| | Part - Sanitized Copy Approved for Release 2012/04/11 : CIA-RDP78-03642A000300020013-2 | |
|-----------|---|----|
| | May 23, 1960 | |

INVESTIGATION OF APPARENT INSENSITIVITY OF LRSR-1B RECEIVERS

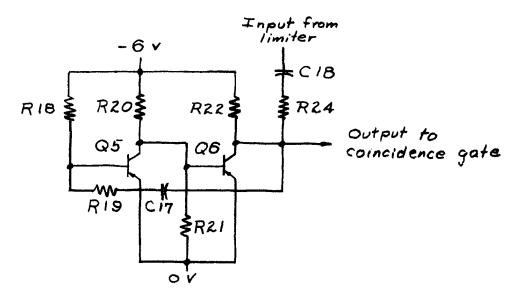
The reference multivibrator portion of the receiver circuit is reproduced in the figure above. It is a mono-stable or "one-shot" multivibrator which is intended to fire on any positive going waveform input from the limiter and which delivers a negative going signal to the coincidence gate at a predetermined interval after it has been triggered. Thus, in the normal operation of the LRS System, this multivibrator flips twice each time the transmitter key is depressed—once at the beginning of the protective pulse and once at the beginning of the operating pulse. The negative going output occurring after triggering caused by the protective pulse has no effect, but the negative going pulse occurring after triggering caused by the operating pulse will be passed by the coincidence gate and will cause triggering of the relay in the receiver.

Upon investigation, it was noted that in the Type "B" receivers, this reference multivibrator was only flipping once unless an RF signal sufficient to saturate the limiter was present. This, then, was the reason for the failure of a lesser RF signal to cause triggering. An examination of the circuit in detail will be necessary to determine a cure for the trouble.

In the normal state, Q5 is conducting and Q6 is not conducting. Any positive going input from the limiter is divided across the combination of R24 and R22, thus raising the collector of Q6 more positive. This lesser positive rise is further coupled by means of C17 to the base of Q5, after

further being divided by the combination of R18 and R19. Because of these two successive divisions of the signal, the net rise at the base of Q5 is less than 12% of the rise occurring in the input waveform. If this rise is sufficient to begin to cut off Q5 (as it should be), the voltage at the collector of Q5 will drop. Since this point is directly connected to the base of Q6, Q6 will be turned on. This will cause a further rise at the collector of Q6 which will reinforce the original signal and the whole process occurs essentially instantaneously with the result that Q5 is turned off, and 06 turned on. Cl7, which was originally charged plus to minus (reading left to right in the figure) now sees a reversal of potential and begins to charge to the apposite polarity through the path consisting of resistors R22, R18, and R19. When the net charge across C17 has reached approximately zero, the base of Q5 reaches the turn on point since the base of Q5 is held above the collector of Q6 by a voltage equal to the charge across C17. When 95 begins to turn on, the collector of 95 rises towards zero volts and this effectively turns off Q6. The ensuing drop in the collector of Q6 will not, however, serve to reinforce the signal causing the turn-on of Q5 since the collector of Q6 will be held with respect to the base of Q5 by the charge on C17. The initial bias conditions will not again be reached until the original plus to minus charge is built up on Cl7. This must occur through the same path as the discharge occurred-that is through R22, R18, and R19. Thus it takes considerable time. If the second rising waveform occurs at the input before the initial state of charge is reached on Cl7, this abnormal bias will cause further attenuation of the input signal which will be sufficient to keep the multivibrator from triggering.

Three possible solutions are apparent as follows: i) Reduce the division ratio of the R24-R22 divider by decreasing the magnitude of R24; ii) Reduce the division ratio of the R19-R18 divider by decreasing the magnitude of R19; iii) Increase the length of the transmitted protective pulse by increasing the magnitude of C3 in the transmitter. Of these three methods, method (i) appeared to give the best results on test. Method (ii) also worked, but the width of the operating pulse was more critical than normal-being about 0.5 ms. Method (iii) which involves a change in the transmitter and therefore is the only feasible method for installed equipment, will work, but results in an extremely critical value of pulse width. It is therefore not recommended for a permanent fix. The value of C3 should be increased from 0.068 mf to 0.078 by the addition of a 0.01 mf capacitor in parallel with the existing capacitor.

Method (i) as stated appears to give the Type "B" units performance essentially identical with that of the "A" units. The value of R24 should be changed to 24K. This can be done either by replacing R24 or by paralleling it with another 47K. While this change can also be made in the "A" units, it will result in increasing the sensitivity of those units with the effect that RF signals sufficient to drive the limiter only to -2.0 volts will cause triggering to occur.
